**REBUTTAL PROOF**

**James McMahon in relation to the Proof**  
**of**

**THE METROPOLITAN BOROUGH OF STOCKPORT (HAZEL GROVE (A6) TO**  
**MANCHESTER AIRPORT A555 CLASSIFIED ROAD) COMPULSORY PURCHASE**  
**ORDER 2013**

**VOLUME 2 - APPENDICES**

Figure 1: Land within the Order(s)

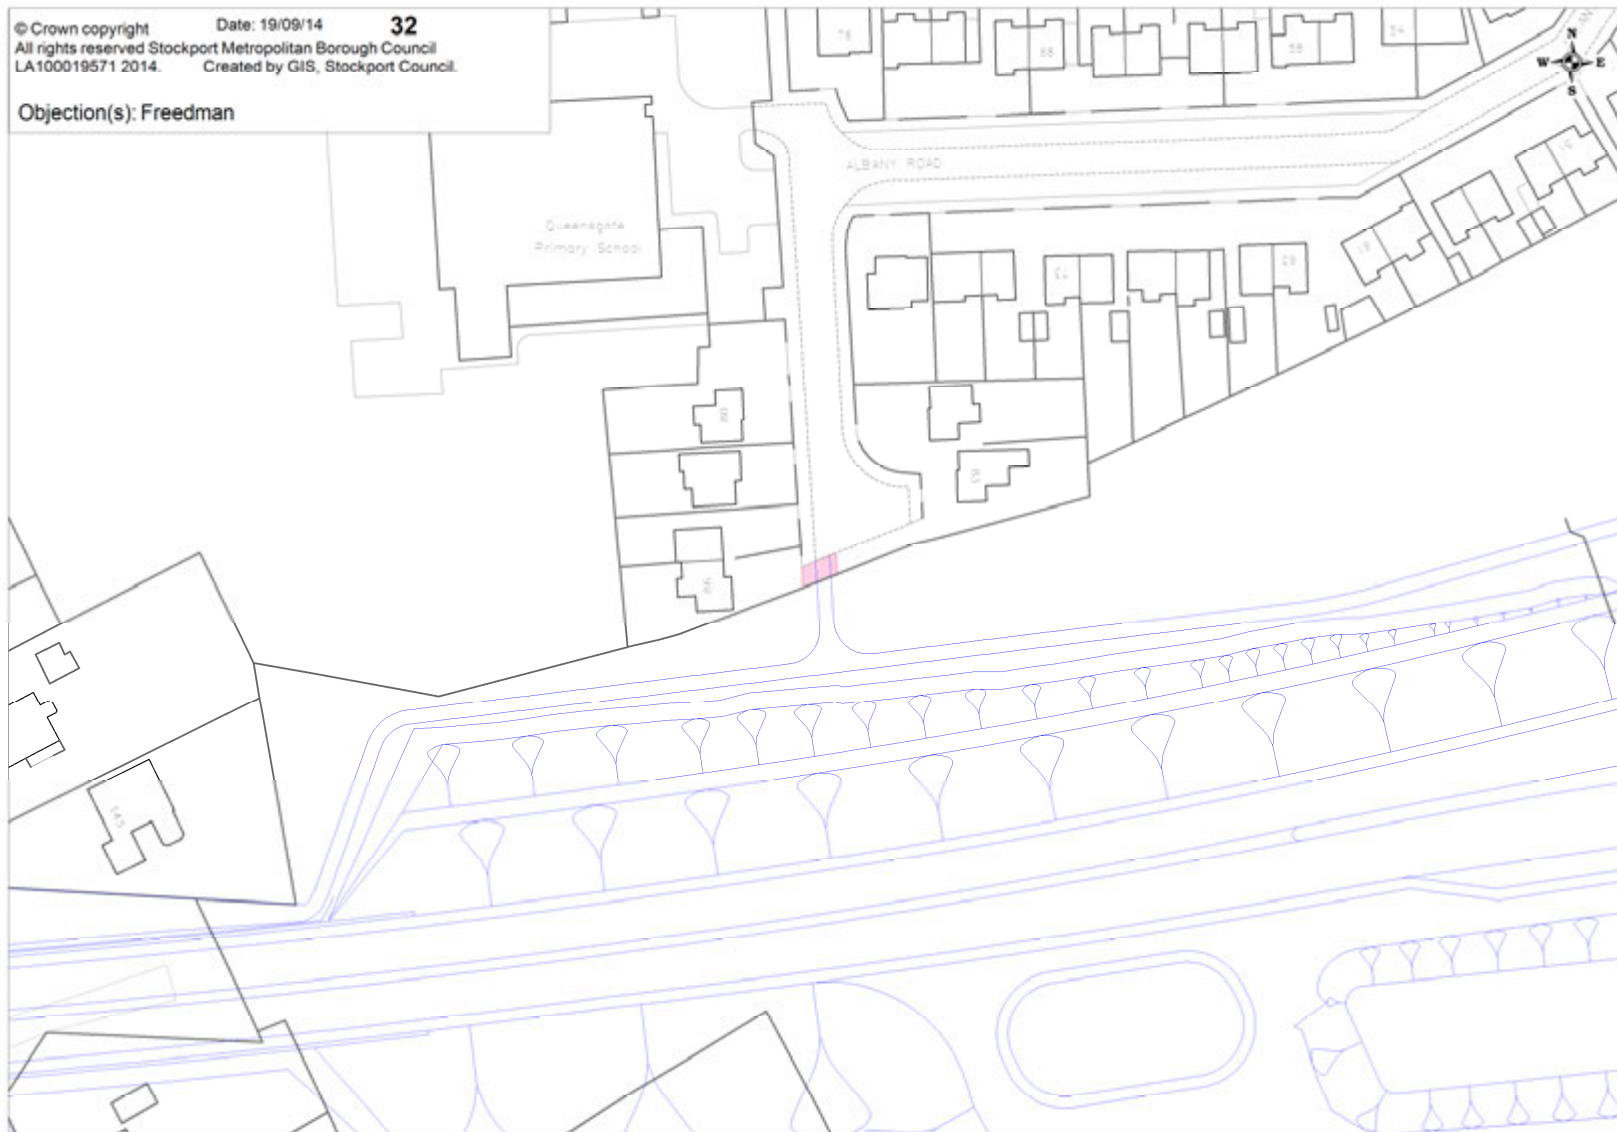
A plan showing the relevant land contained within the order(s) is shown at Figure 1.
